Mounting instructions of fuel module 7506413 (Design Marwal)

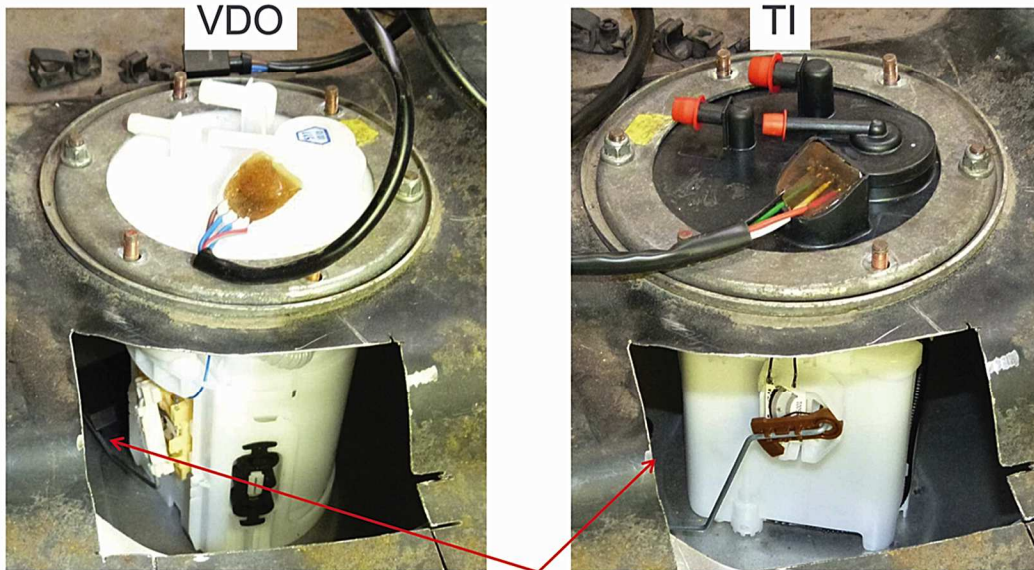
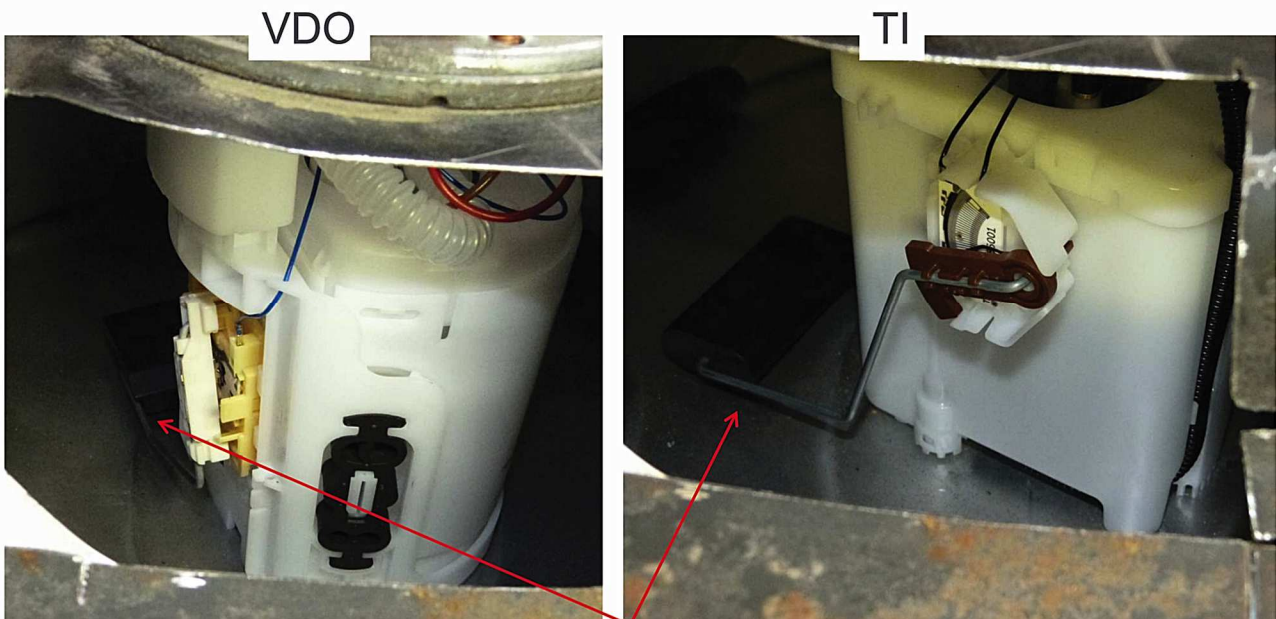
Orientation of the level sender is not exactly the same but they both are on the bump border at bottom position.

Mounting instructions of fuel module 7506413 (Design Marwal)

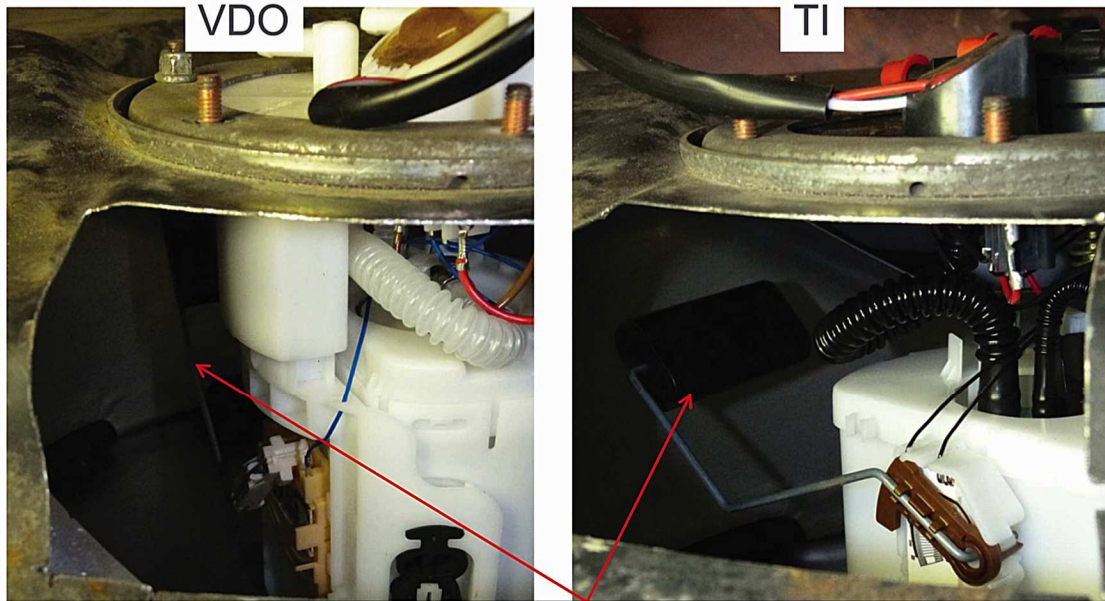
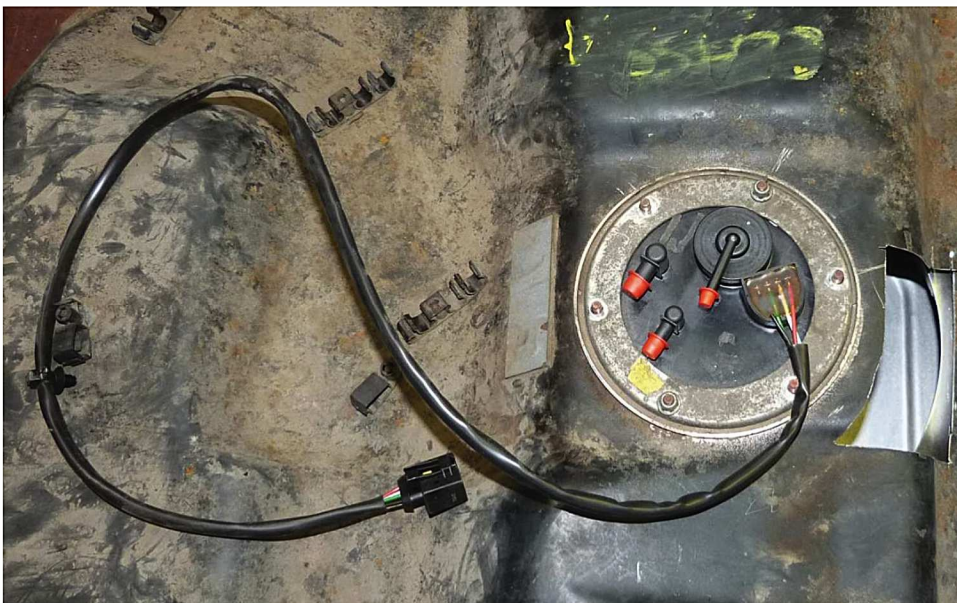
There is no interference with the fuel tank from the empty up to the full level.

Since there is no marking on the fuel tank, wrong orientation of the fuel level sender could be the cause of a defect.
